Jonathan Rowley - TLAA RAI Response

**Subject: Vermont Yankee Nuclear Power Station
License No. DPR-28 (Docket No. 50-271)
License Renewal Application, Amendment 33**

RAI 4.3.3-2 Additional Information

RAI 4.3.3-2

Figure 1: Feedwater Nozzle - Safe End 100% Flow Total Stress Intensity
Reference: VY-16Q-301 Revision 0

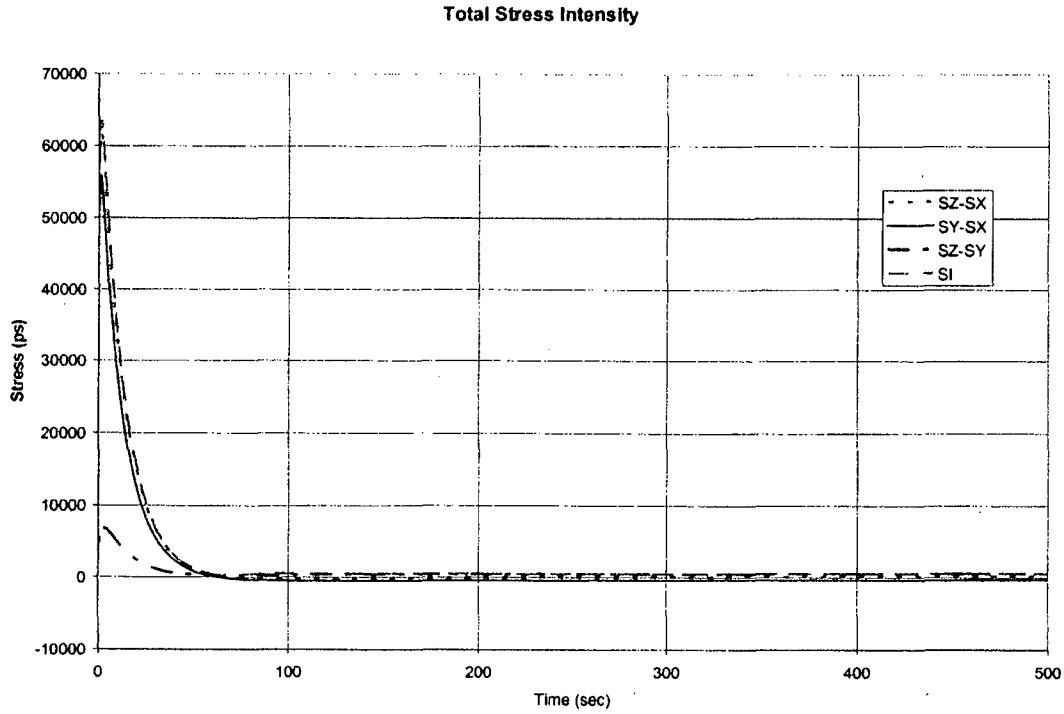
Your response to audit question # 387 in your November 14, 2007, letter states that "In most cases the maximum component stress difference with time matched the maximum stress intensity calculated by ANSYS. This shows that shearing stresses are negligible for the thermal transient at that location and the maximum component stress difference is the maximum stress intensity."

Please identify the exceptions where maximum component stress difference with time did not match the maximum stress intensity calculated by ANSYS. In addition, please justify the exceptions, based on quantitative evaluations, that the shearing stresses are negligible and the maximum component stress difference is the maximum stress intensity for the branch nozzle blend radius (nozzle corner) locations with geometrical discontinuities for the applicable thermal transients. Your response should cover the shearing stress differences at the 0-180 degree axis and the 90-270 degree axis to the pipe run axis.

The Feedwater nozzle has the highest fatigue usage. Figures 1 and 2 show the stress response for a 500°F to 100°F temperature step transient at the nozzle safe end and blend radius locations. For both locations the SZ-SX component stress difference closely matches the maximum stress intensity calculated from ANSYS. As shown in Figure 1 for the controlling location on the safe end, the SZ-SX component stress difference is approximately 3% lower than the maximum stress intensity calculated by ANSYS for all time steps with significant (> 1000. psi.) stress values. As shown in Figure 2, for the nozzle blend radius location, the maximum component stress difference for the step transient matches the maximum stress intensity calculated by ANSYS within 1% for all time steps with significant stress response.
